SHOREHAM NUCLEAR POWER STATION

SNRC-1141

Fire Protection
Shoreham Nuclear Power Station - Unit 1
Docket No. 50-322

Reference 1: Letter NRC (Thomas T. Martin) to LILCO (J. D. Leonard) dated 12/21/84 forwarding Inspection Report 84-46

CEL	MECH	VESEL	SS	ELEC	INSTR	DATE	ISSUE	DESCRIPTION	CHKD	CORR	APPR	DATE	ISSUE	DESCRIPTION

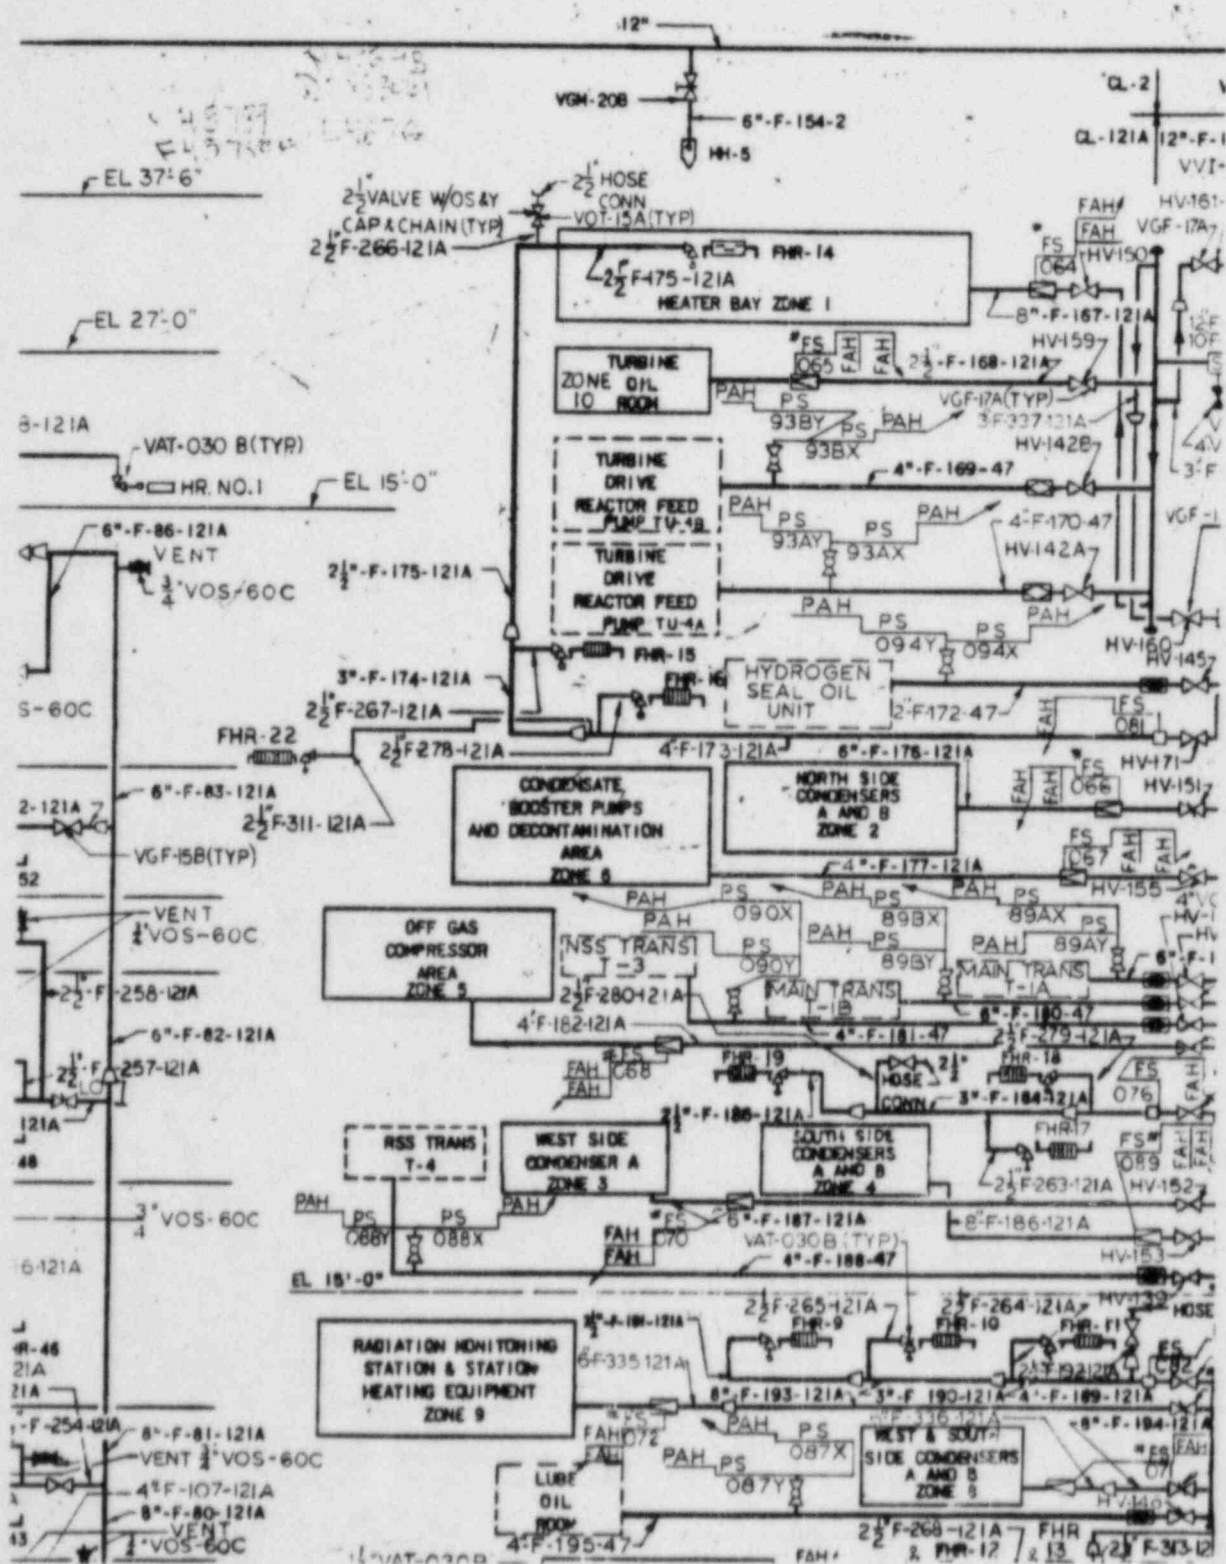
Unresolved Item 84-46-14 - Single Header in the Reactor Building

Branch Technical Position 9.5-1 Appendix A requires that a single failure not impair the fire suppression system. LILCO complies with the BTP. With respect to the single header in the Reactor Building, LILCO has utilized the guidance of MEB-1 in determining that the postulated pipe failure for this moderate energy system would result in a crack producing a leakage of 165 gpm. Such a failure would not impair the fire suppression system in the Reactor Building since each fire pump has a rated capacity of 2500 gpm.

The single header configuration utilized at Shoreham was inspected and reviewed by the NRC during the FSAR review process (1979-1980). As a result of a staff question (FHAR Question 1), a redundant feed to the Reactor Building was installed. With this modification, the Staff accepted the design of Shoreham's fire header for the Reactor Building.

A copy of drawing M-10661, Rev. 12, "Water Fire Protection System" is enclosed, showing the water suppression system in the Reactor Building. Shoreham Technical Specifications require that if the fire suppression water system becomes inoperable, a backup fire suppression water system must be established within 24 hours. From the enclosed figure it can be seen that certain non-postulated circumferential breaks in the Reactor Building could be isolated and backup suppression established via hose reels or extinguishers. Depending on the location, certain other non-postulated breaks could render the fire suppression system temporarily inoperable. If backup suppression could not be established, LILCO would bring the plant to the shutdown condition.

The FSAR has always contained the single header configuration. The NRC accepted this configuration and LILCO believes that a backfit is not justified.
